Attitude On Food Commercial - Catering Kitchen

7758 Cass Street
Omaha, NE 68114

8/9/2024, 9:53:03 AM
BLD-24-03012

CODE REVIEW

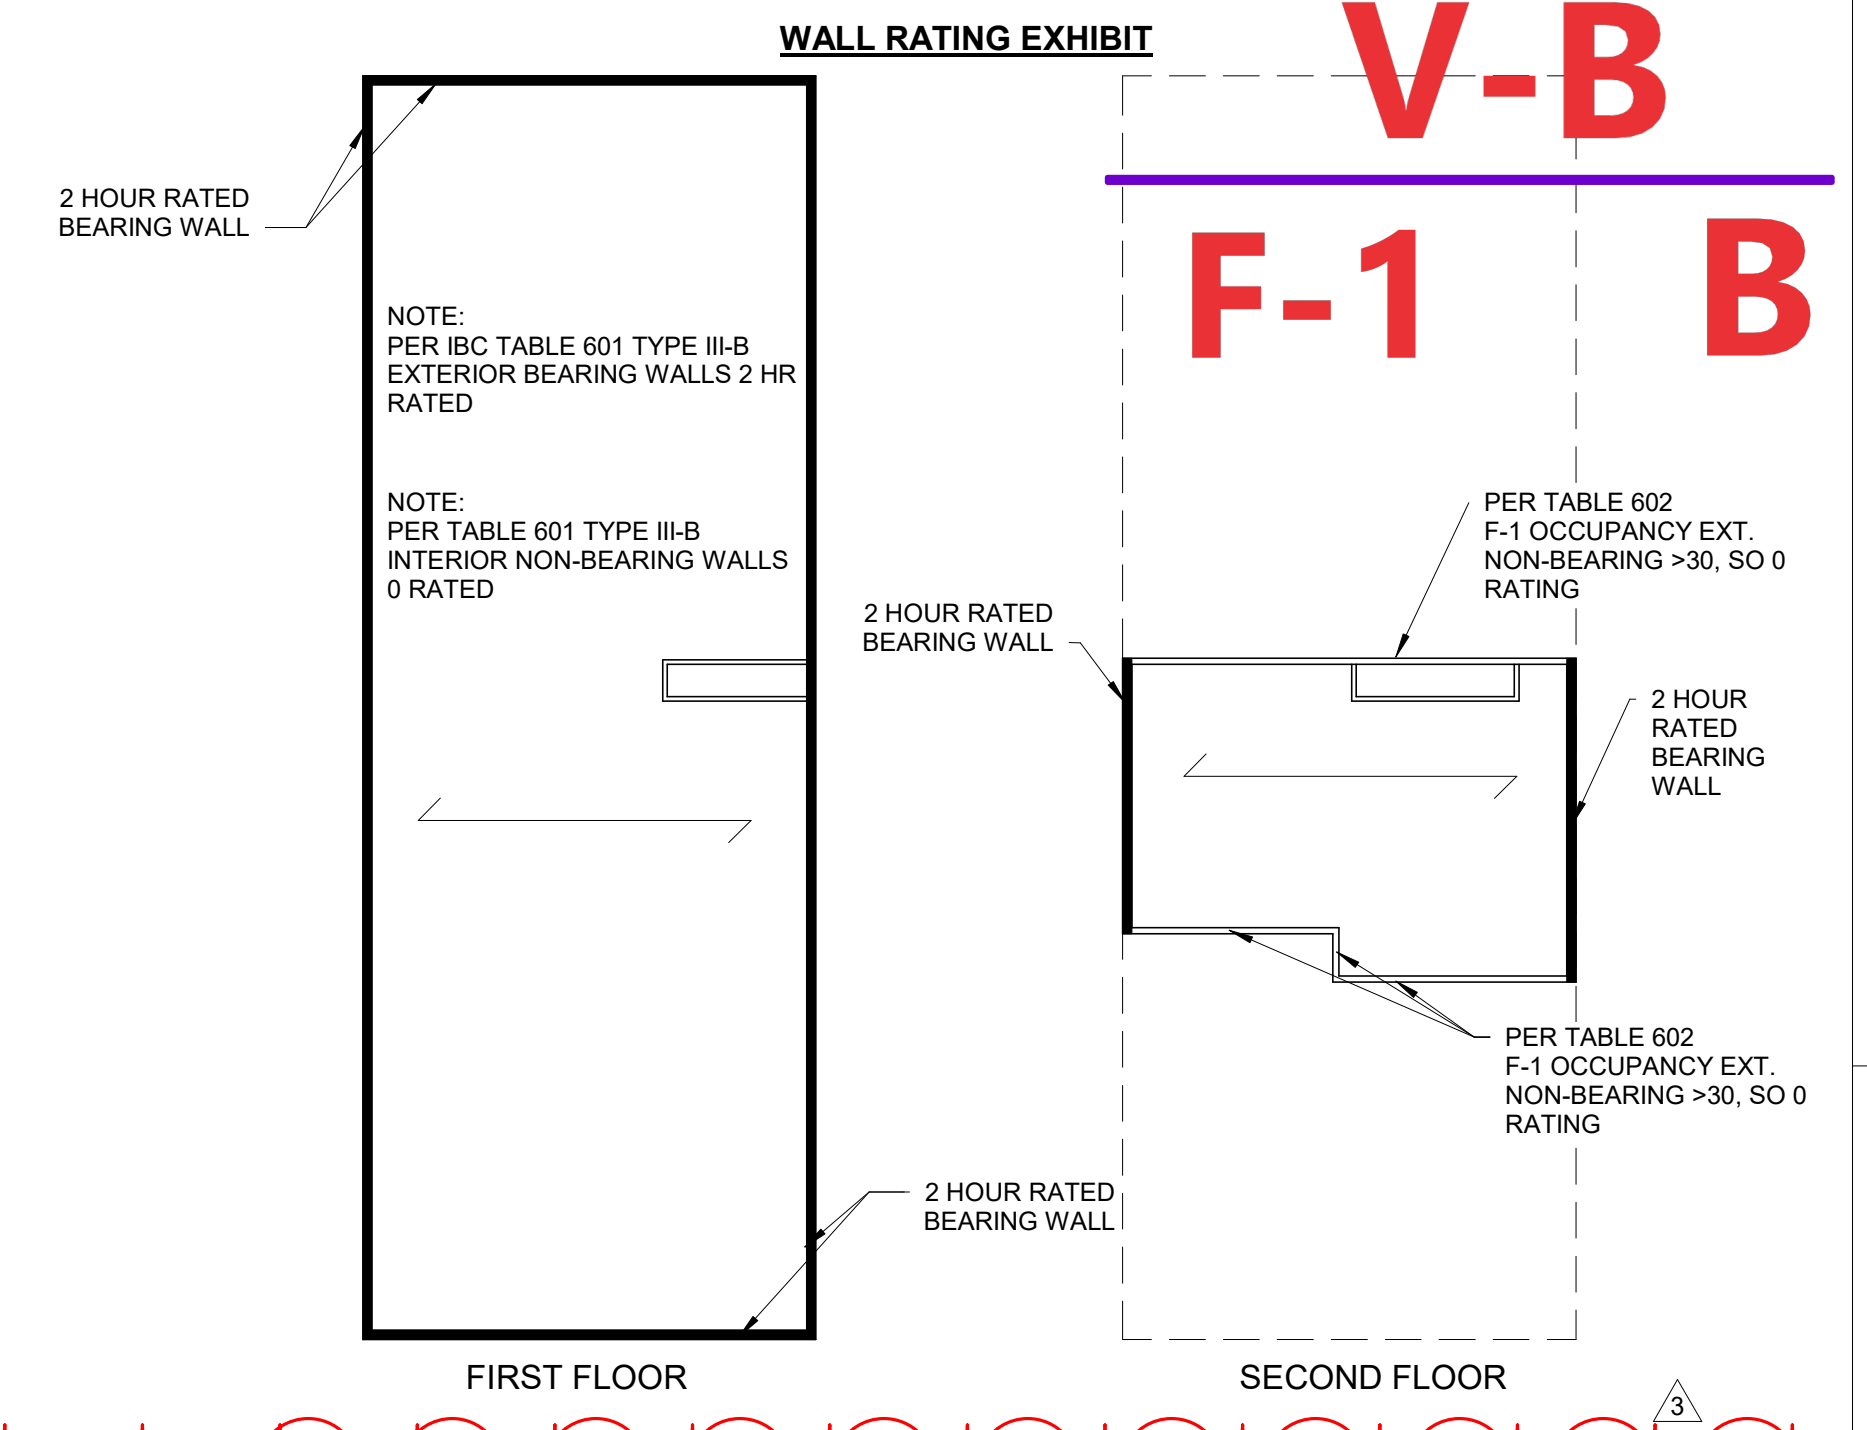
00011 - FIRE (Kurt Urkoski)
Occupant load shall be calculated at the most restrictive. Per LSC

00001 - COMM (Le Nguyen)
Change of use shall require new Certificate of Occupancy.

PER 2018 IBCB SECTION 301.3
"CHANGE OF OCCUPANCY" METHOD OF COMPLIANCE

PER IBCB TABLE 1011.4
M OCCUPANCY = CATEGORY 3
F-1 OCCUPANCY = CATEGORY 4
PER TABLE 1011.4
CATEGORY 4 LESS RESTRICTIVE THAN CATEGORY 3.
THEREFORE, FRONT ENTRY VESTIBULE DOORS TO REMAIN.

PER IBCB TABLE 1011.5
M AND F-1 ARE BOTH CATEGORY 3
HEIGHT AND AREA ARE IN COMPLIANCE WITH IBC 2018.

PER IBCB TABLE 1011.6
M AND F-1 ARE BOTH CATEGORY 2
NO CHANGE REQUIRED.

PER 2012 LSC 43.1.1
"CHANGE OF USE OR OCCUPANCY" CLASSIFICATION

PER 2012 LSC TABLE 43.7.3
EXISTING MERCANTILE AND PROPOSED ARE BOTH HAZARD CATEGORY 3.

2012 LSC TABLE 7.3.1.2
First Floor:
Business Areas = 4,427sf/100 = 45 occupants
Kitchen Areas = 2,276sf/100 = 23 occupants

D4 FIRST FLOOR LIFE SAFETY PLAN
 1/8" = 1'-0" 0" 12"

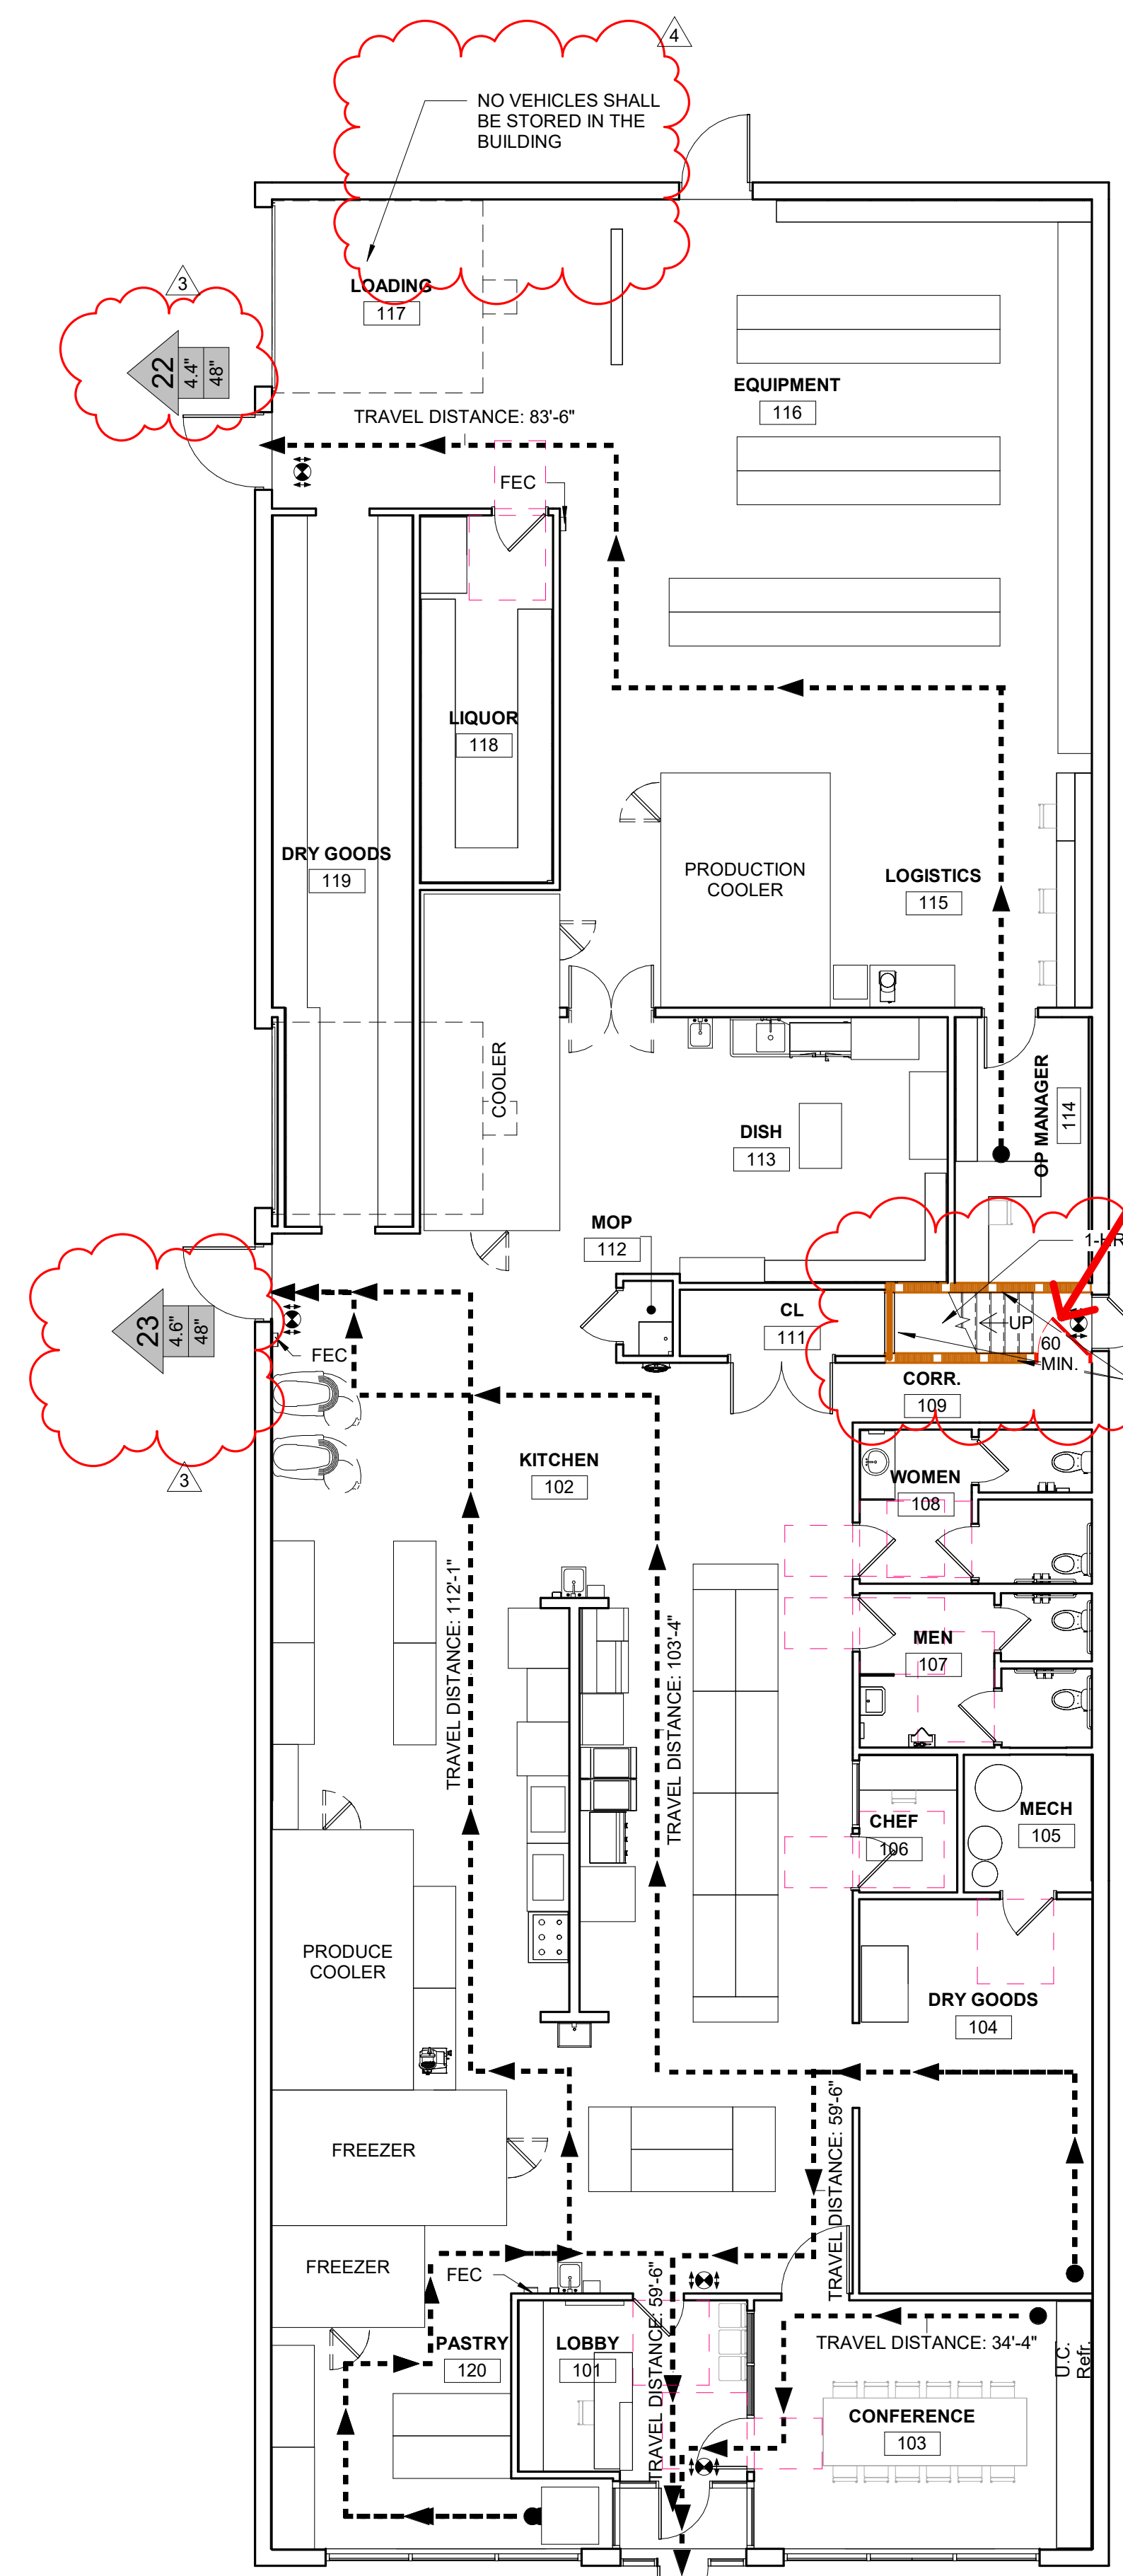
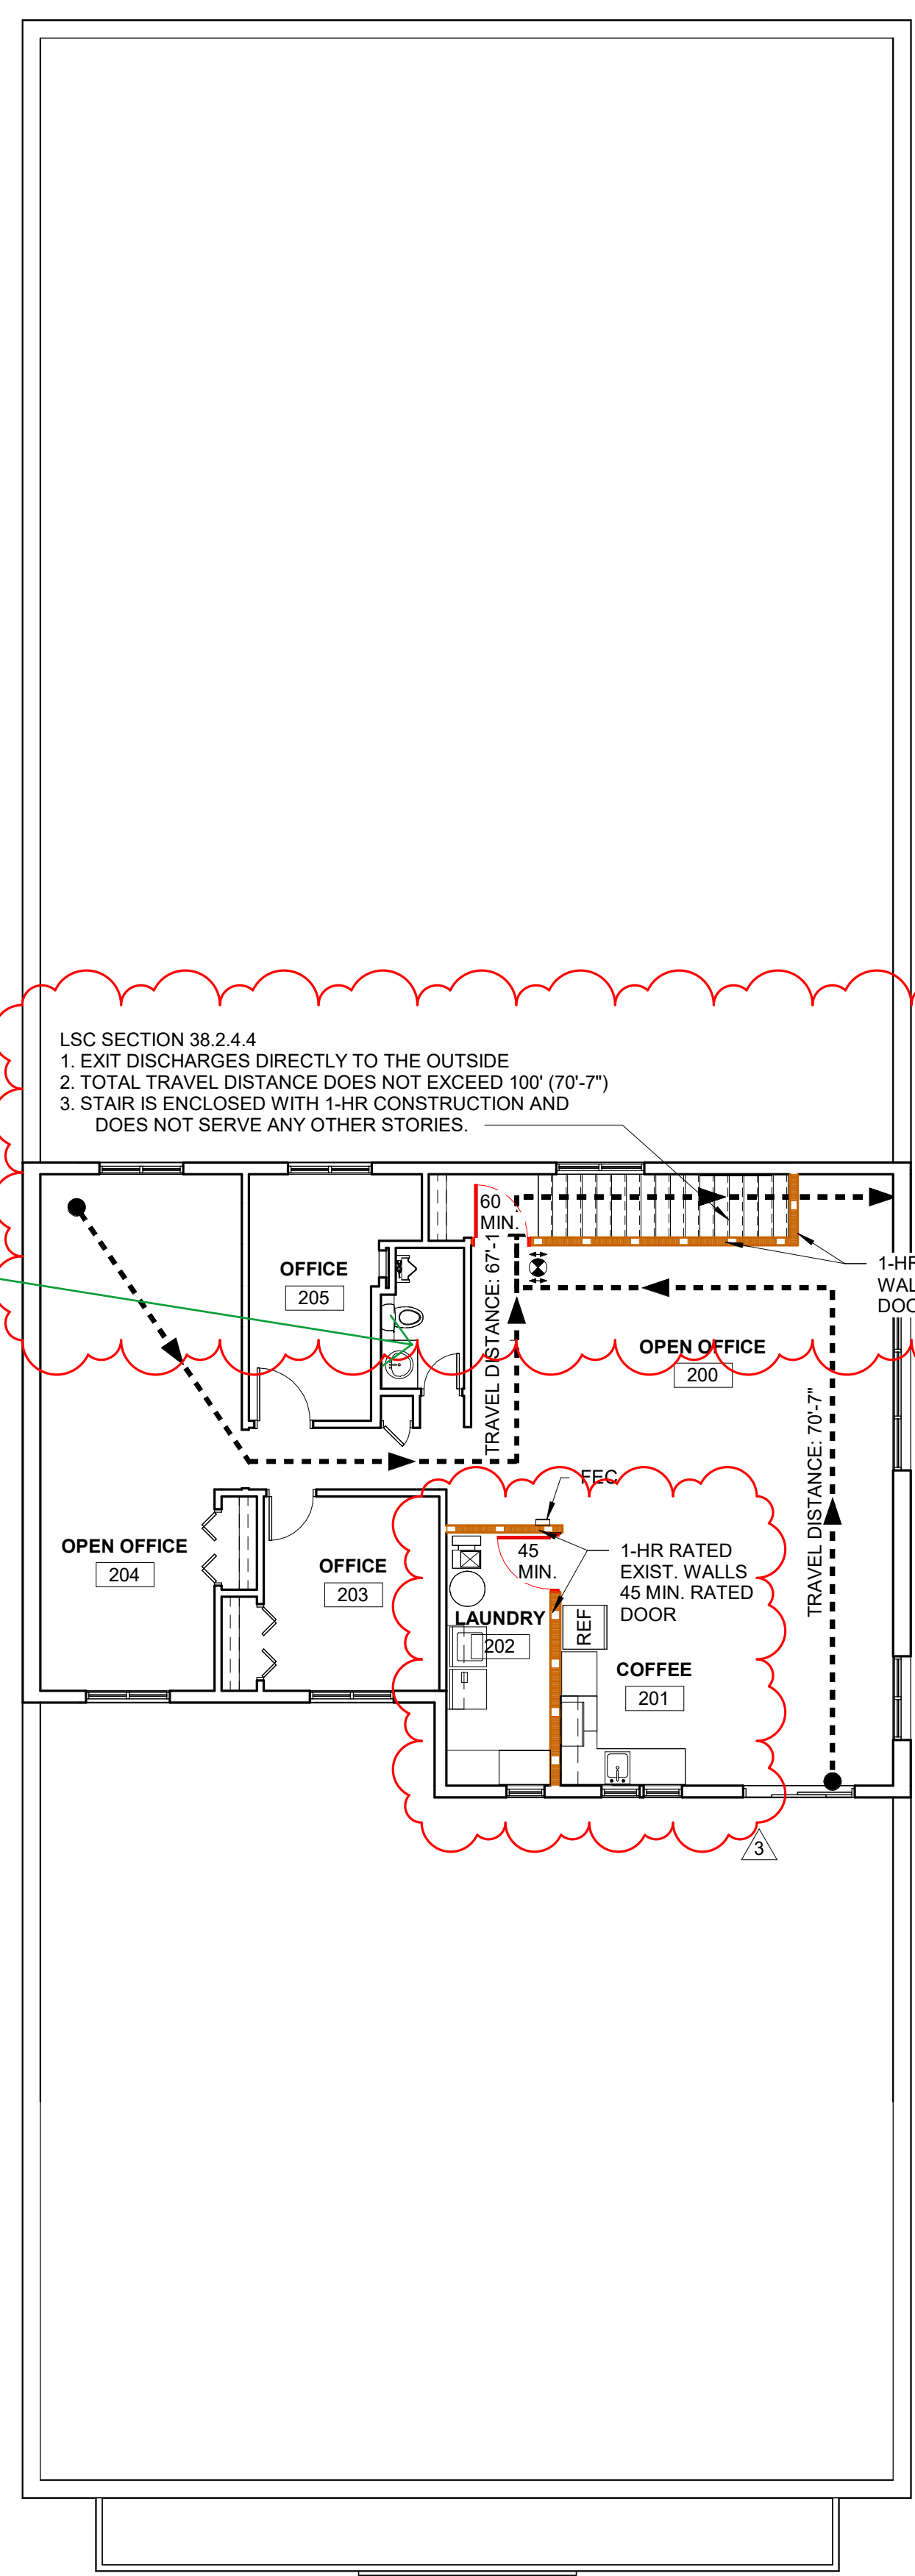
MPE COMMERCIAL KITCHEN HOODS COMMENT:
